Project:
WOODLAND OAKS
LSMO
Issue Date:
February 25, 2021

Sanitary Details

Construction Plans for:
WOODLAND OAKS

ODOR/CORROSION CONTROL SYSTEM SPECIFICATION:

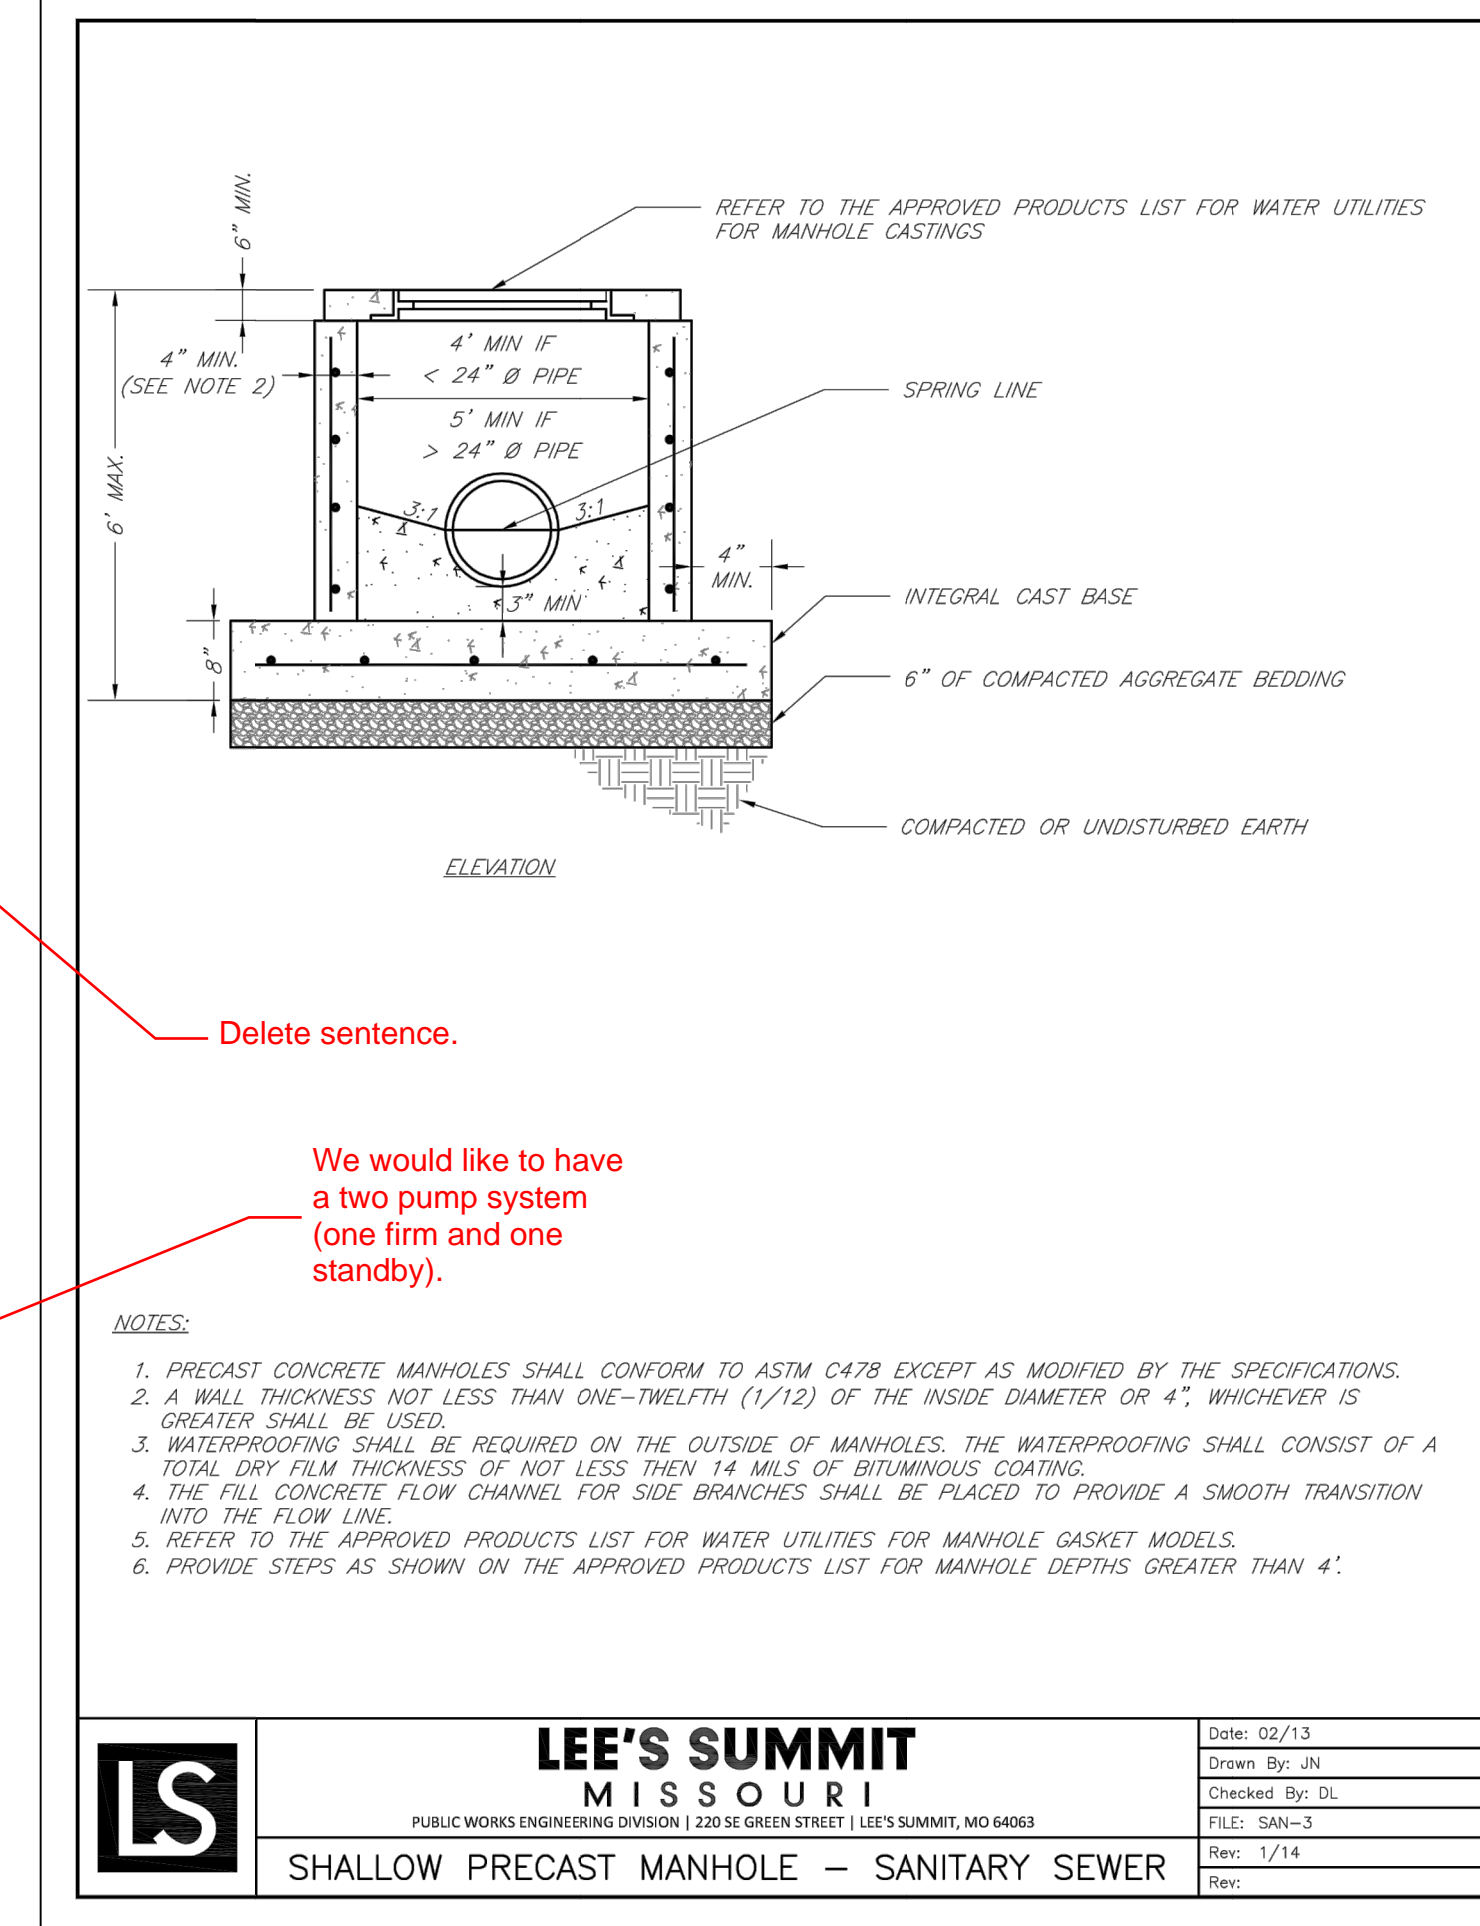
Gene, I was wondering if we could get some drawings of the control panel and tank. We have two other biocide systems and want to do what we can to make sure the systems are more standardized. Is this the time to do it? Is this a separate phone call with Matt?

Delete sentence.

We would like to have a two pump system (one firm and one standby).

Delete 18 months from shipment, whichever occurs first. Since this will be through the developer's contractor, we can't control shipment and installation.

Was this note a carryover from a detail with a concrete base slab?
